CHRYSLER A604 (41TE) UPDATE HANDBOOK

INDEX

*Updated
May, 2003*

Figure 1

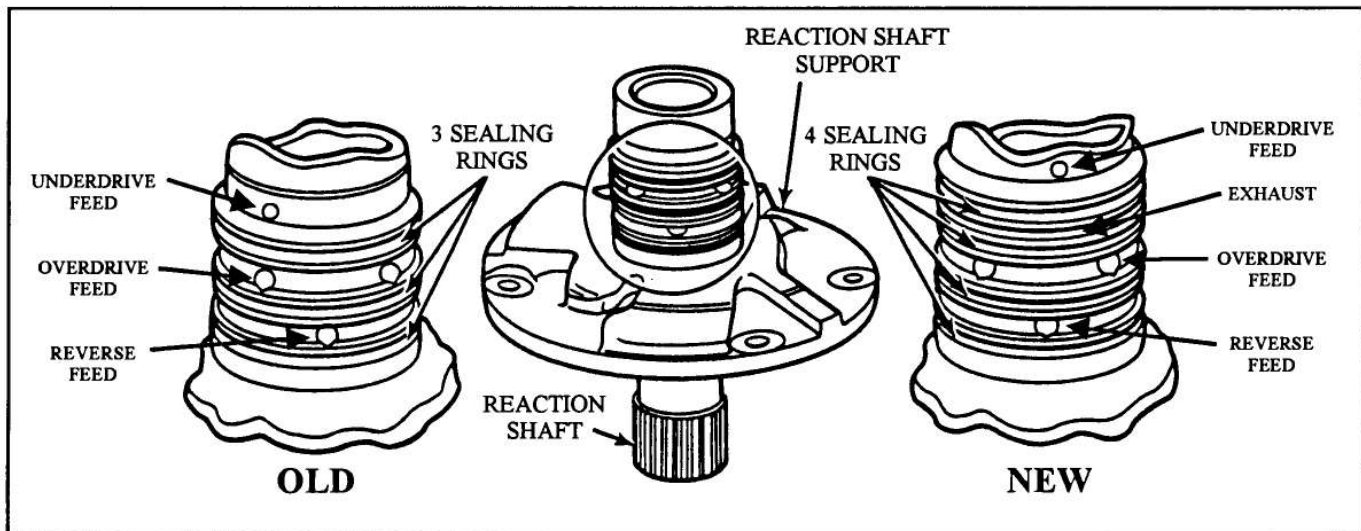
CHANGE: Beginning in April, 1989 a new Reaction Shaft Support (Stator) was introduced, with the addition of another ring groove and sealing ring. The old support has 3 sealing rings, and the new support has 4 sealing rings (See Figure 1).

- (1) **REACTION SHAFT SUPPORT** - The new support is longer, and has 4 sealing rings, where the old support only has three (See Figure 1).
- (2) **INPUT SHAFT/CLUTCH HUB** - The new Input Clutch Hub bore is machined deeper to accommodate the additional length of the reaction shaft, created by the added sealing ring (See Figure 2). The "O" Ring grooves are also cut shallower than the old input clutch hub, which increases the groove diameter, and provides improved compression or "Crush", between the "O" rings and the input clutch retainer. (See Figure 3).

Figure 3

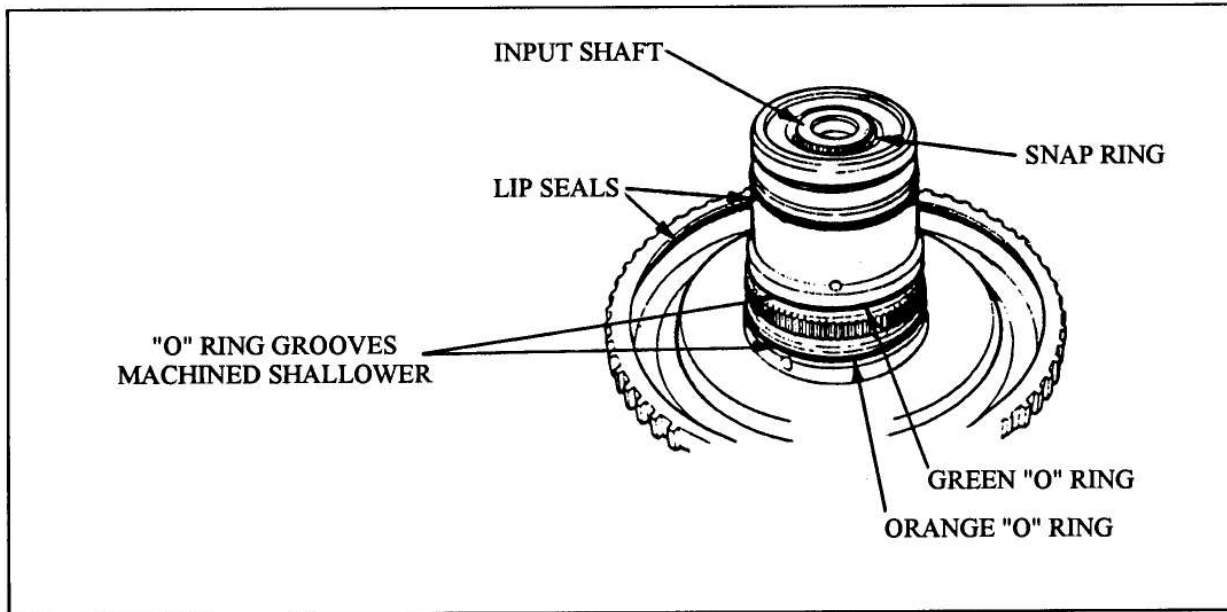
- (3) **INPUT SHAFT/CLUTCH HUB "O" RINGS** - The new "O" Rings are "Teflon Coated" for greater tear resistance during the assembly process. The coatings also identify the locations for the "O" Rings. The orange ring goes to the front, and the green one goes to the rear (See Figure 3). The early "O" rings were black.

Repair Package	4549248
Gasket Package	4504558
"O" Ring (Orange)	6502272
"O" Ring (Green)	6502270
Input Clutch Retainer (No Lip)	4431609

Figure 4

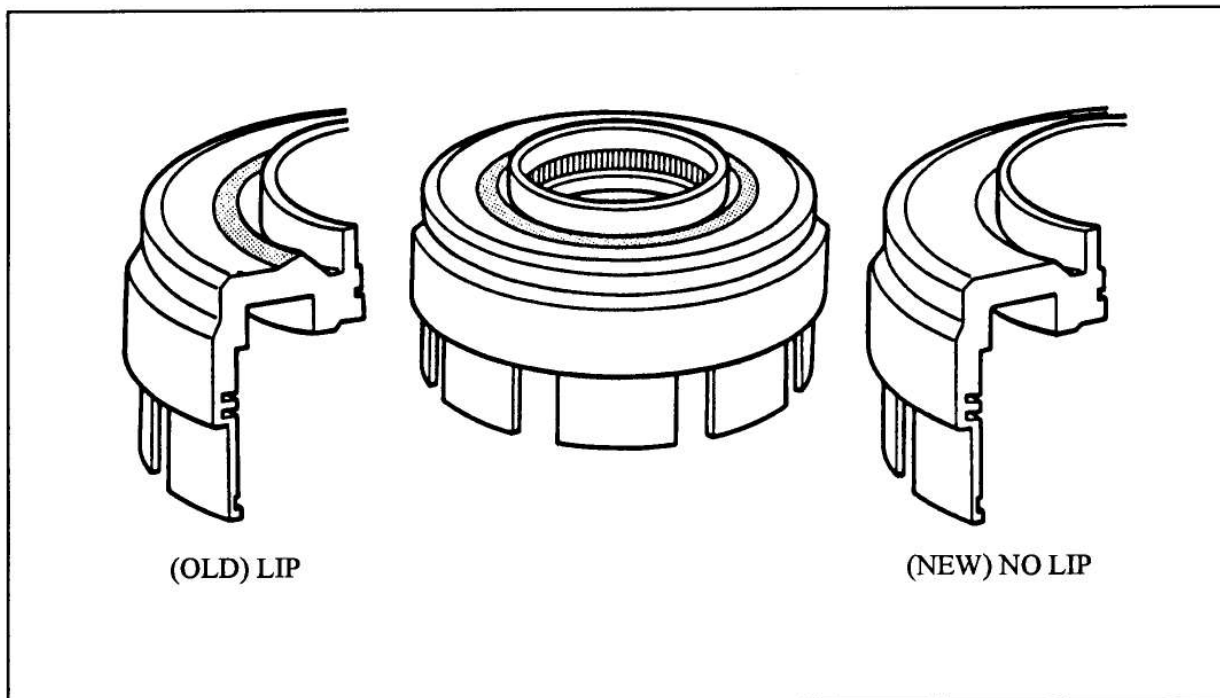
- (4) **INPUT CLUTCH RETAINER** - The Input Clutch Retainer was modified, by machining off the "Lip" (See Figure 4), to allow more travel of the overdrive/reverse piston. The old Input Clutch Retainer can be machined at the local machine shop if necessary.

Figure 5

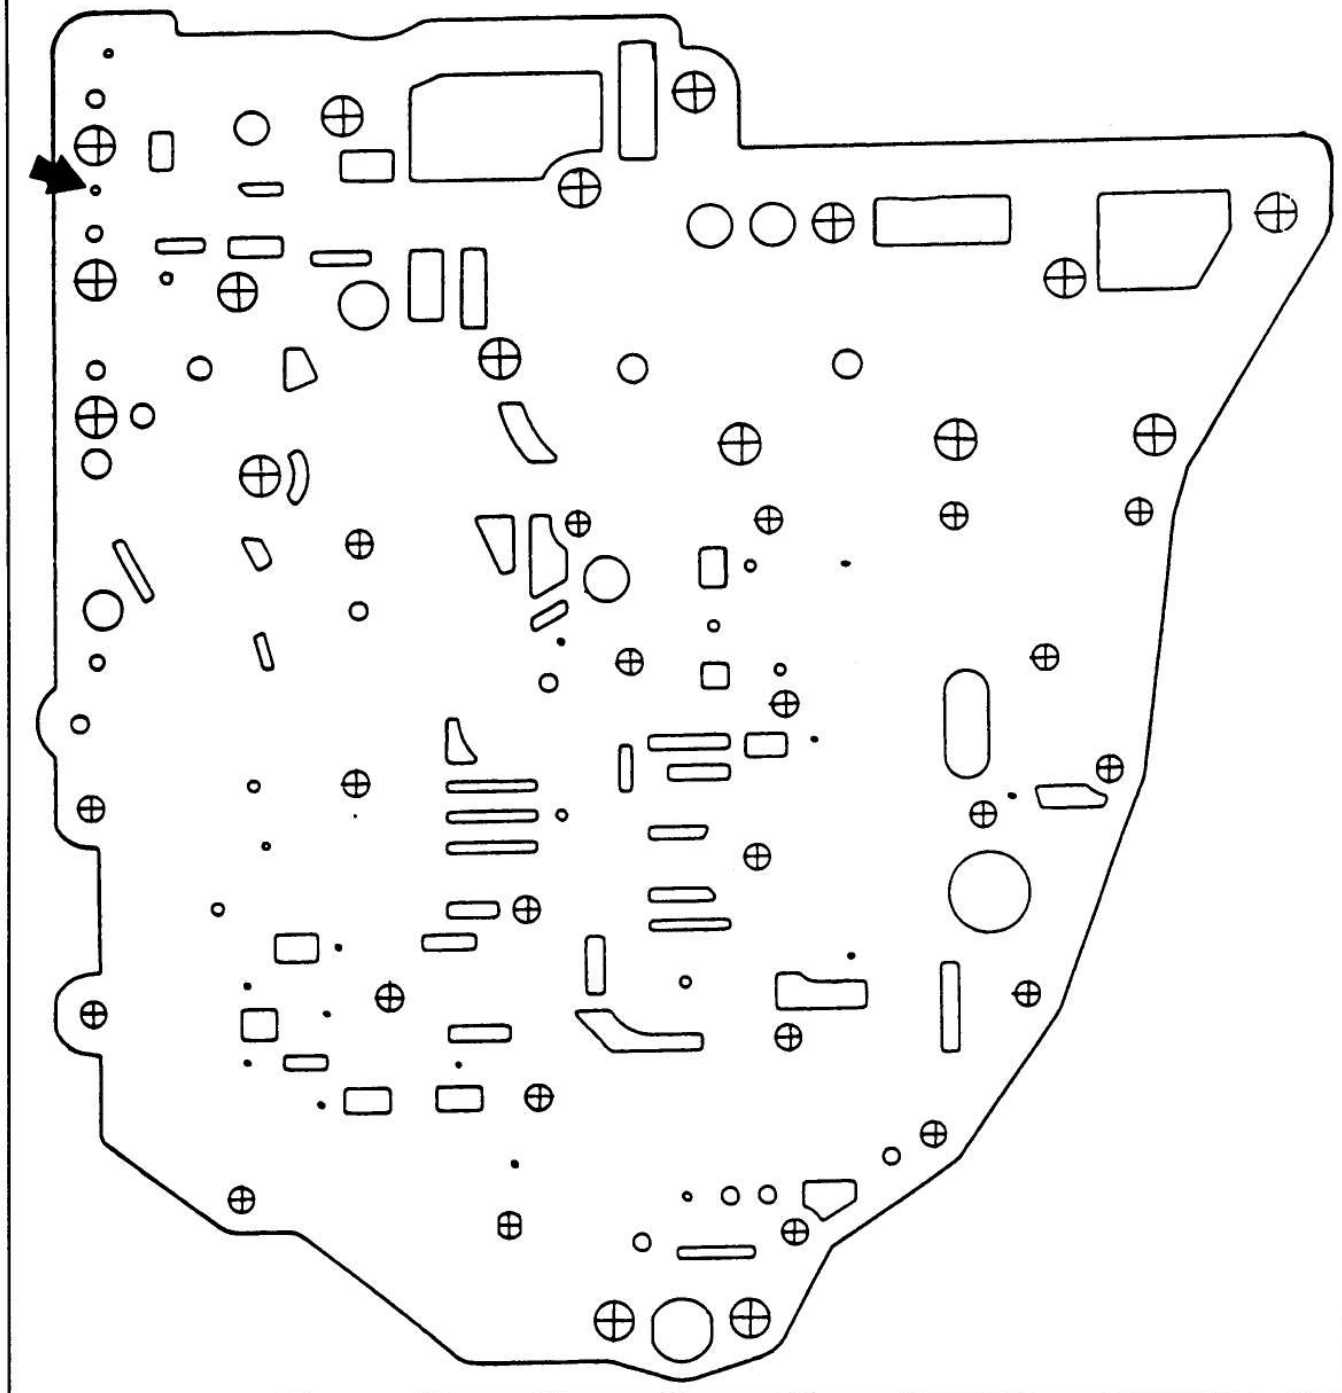
- (5) **SPACER PLATE** - The new Spacer Plate has a larger (.105") overdrive clutch feed orifice to provide increased oil flow to the overdrive clutch circuit (See Figure 5).

THE HOLE INDICATED BY THE ARROW BELOW HAS BEEN ENLARGED TO .105" FOR INCREASED OIL FLOW TO THE OVERDRIVE CLUTCH CIRCUIT.

Figure 6

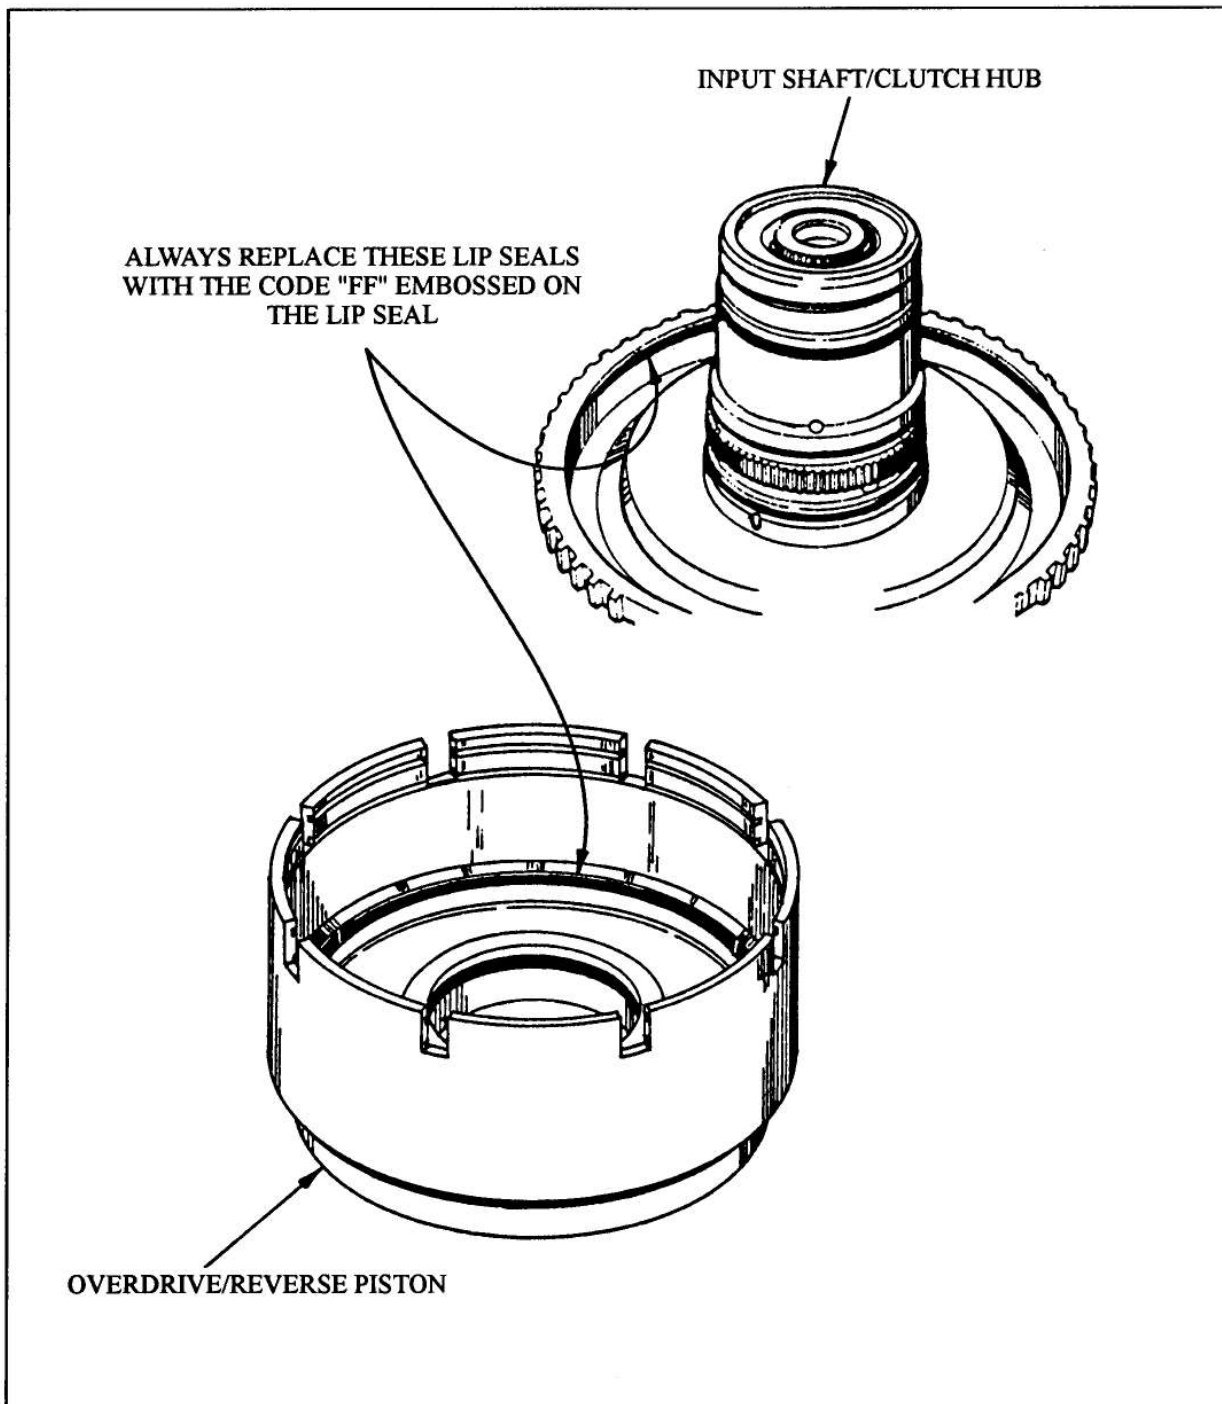
CHANGE: The lip seals in the Overdrive/Reverse Clutch Piston and the Input Shaft/Clutch Hub are now replaced with lip seals made of different material (See Figure 6).

- (1) **OD/REVERSE PISTON LIP SEAL** - No dimensional changes, but the material changes, and the new lip seals can be identified by the code "FF" embossed into the seal. The old lip seal is embossed with the code "IPC", and should not be used (See Figure 6).
- (2) **INPUT CLUTCH HUB OUTER LIP SEAL** - No dimensional changes, but the material changes, and the new lip seals can be identified by the code "FF" embossed into the seal. The old lip seal is embossed with the code "IPC", and should not be used (See Figure 6).

THE NEW LIP SEALS EMBOSSED WITH THE CODE "FF" WILL RETROFIT BACK TO ALL PREVIOUS MODELS, AND SHOULD BE USED DURING OVERHAUL.

Figure 7

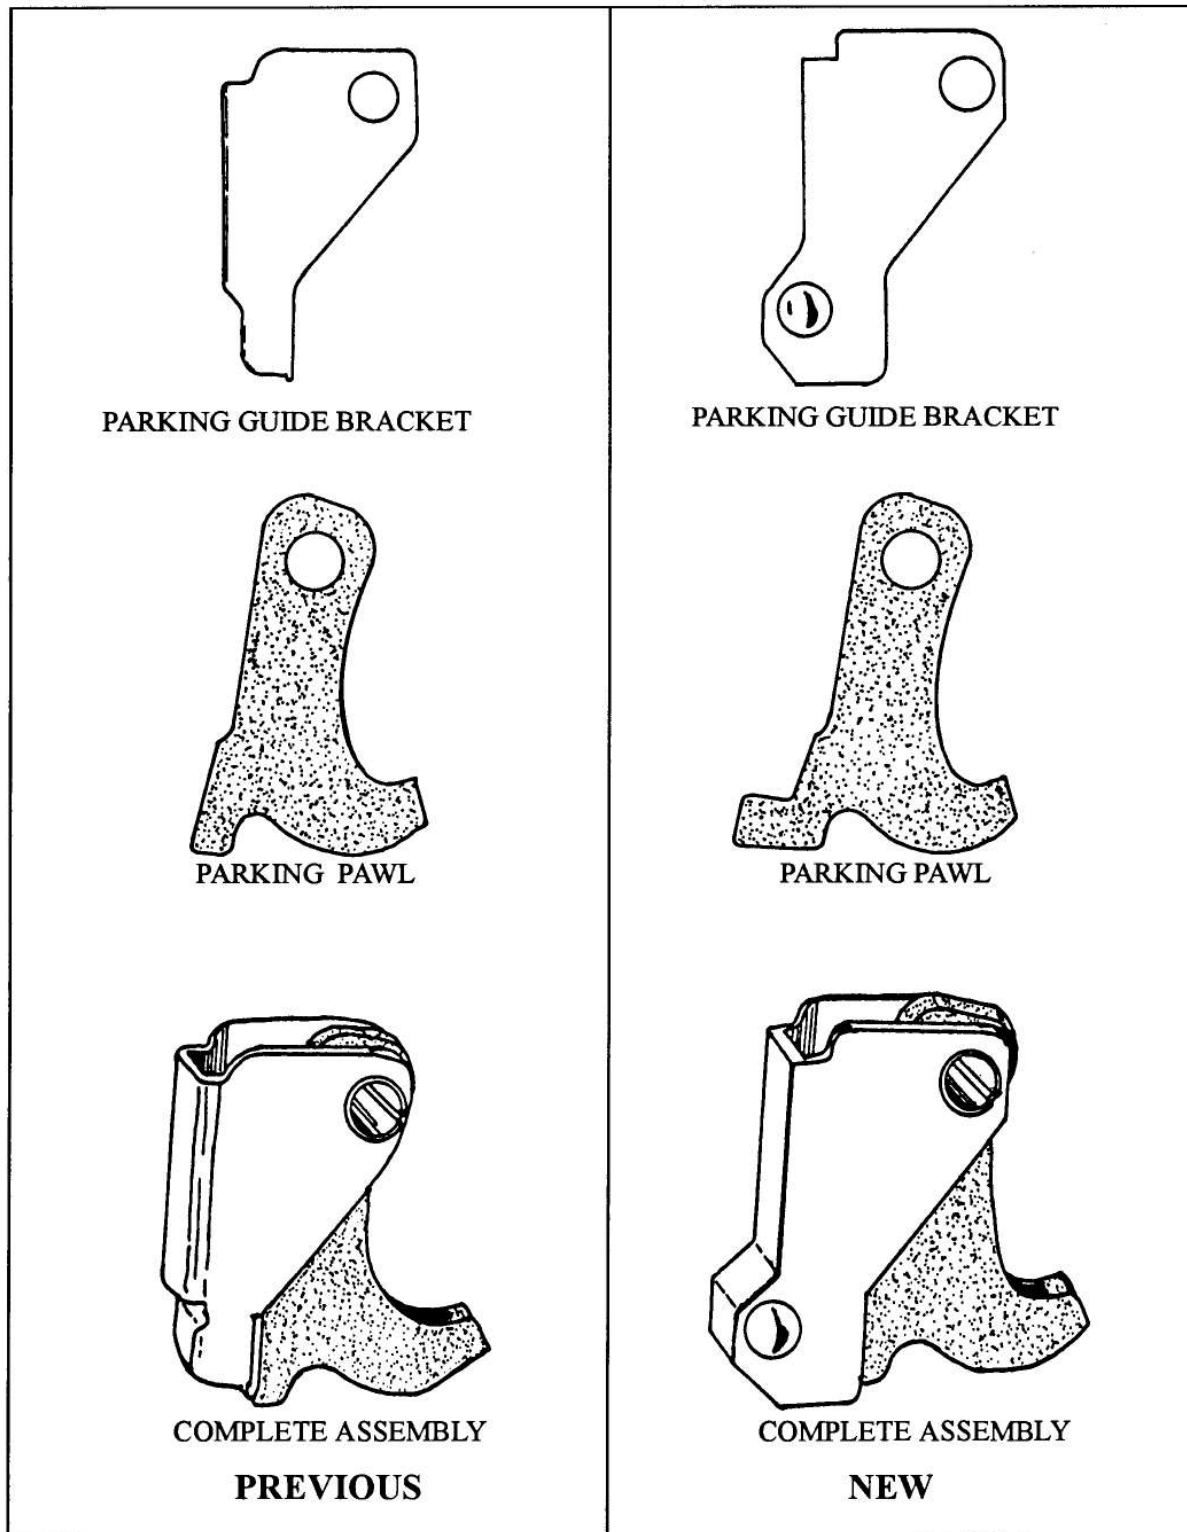
CHANGE: A new Parking Sprag Guide Bracket and Parking Pawl has been introduced as a 1989 running change (See Figure 7).

- (1) **PARKING GUIDE BRACKET** - Previously the Parking Guide Bracket was a stamped steel unit, and has been replaced by a high quality casting, along with dimensional changes. See Figure 7 for identification.
- (2) **PARKING PAWL** - The new Parking Pawl, or "Boot", also required some dimensional changes. The heel of the new "Boot" is wider than the previous models, as shown in Figure 7.

The new parts will retrofit back to all previous models, but both pieces must be replaced as an assembly. (See Figure 7).

Figure 14

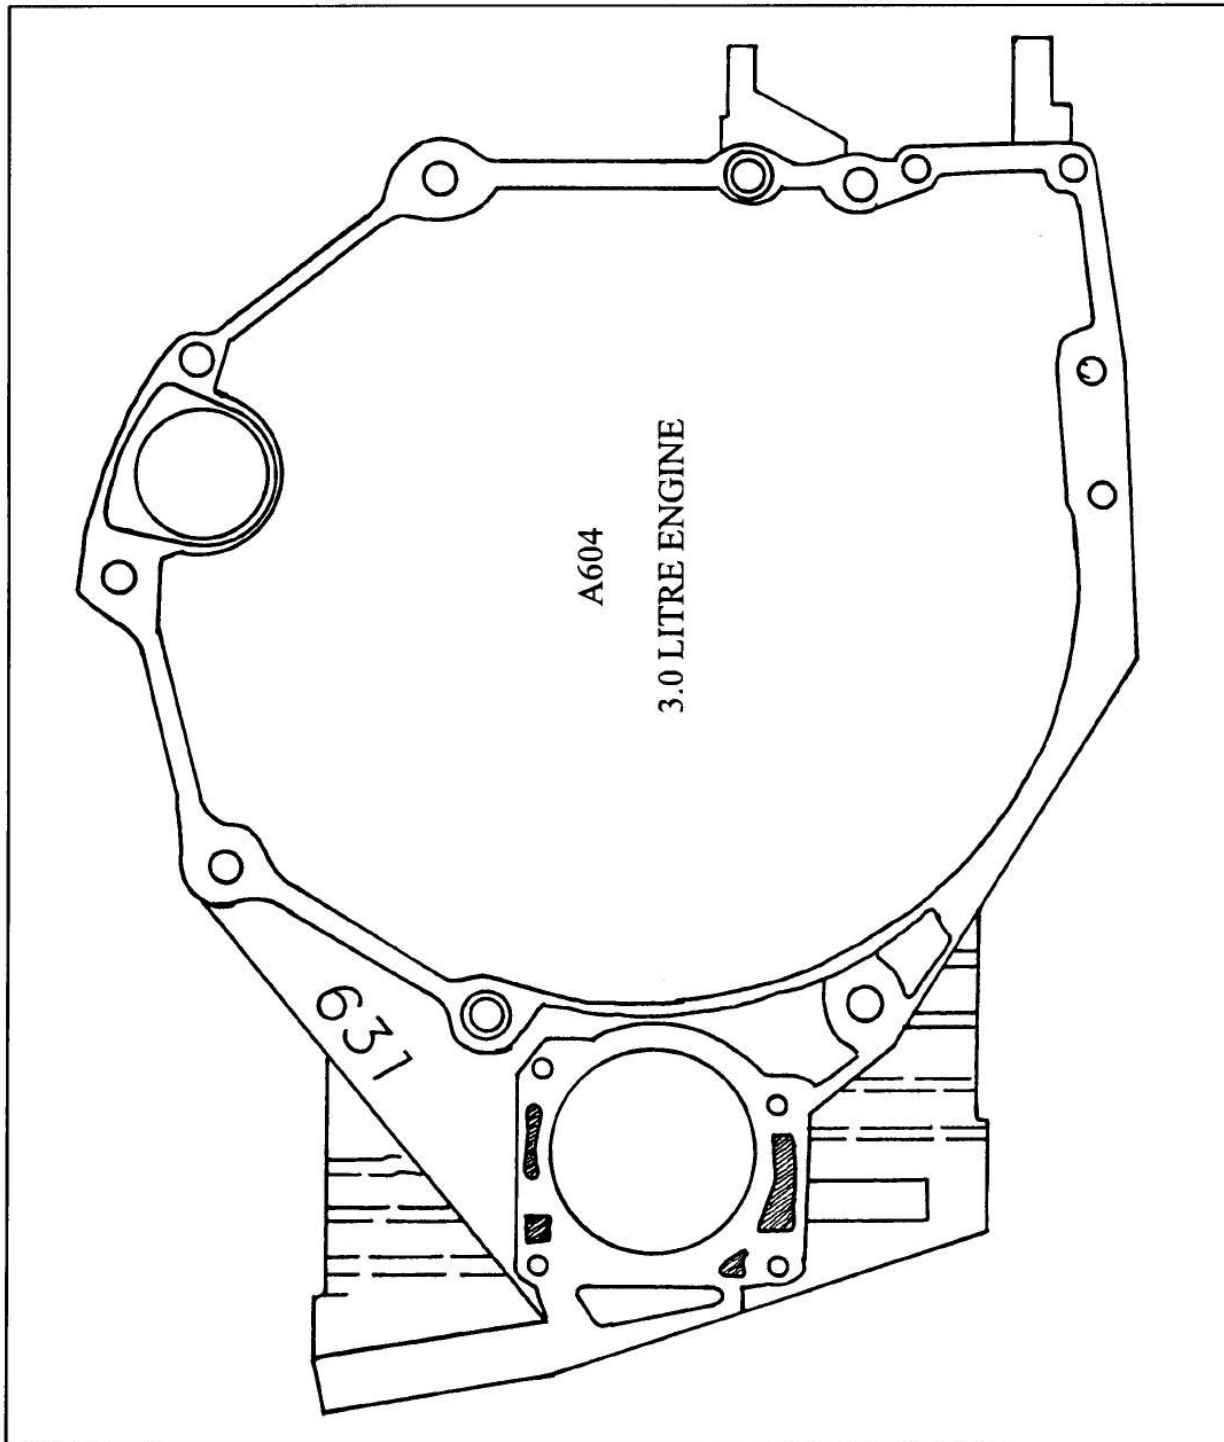
- (2) **TURBINE SHAFT SPLINES** - 1989-1990 2.5 Litre engine uses a turbine shaft with 22 splines for the torque converter, and the 1989-1990 3.0 and 3.3 Litre engines will use the a 24 spline turbine shaft (See Figure 14).

NOTE: All 1991 and up A604 transaxles will use a 22 spline input shaft to fit a new torque converter with a torsional vibration damper (See Figure 14).
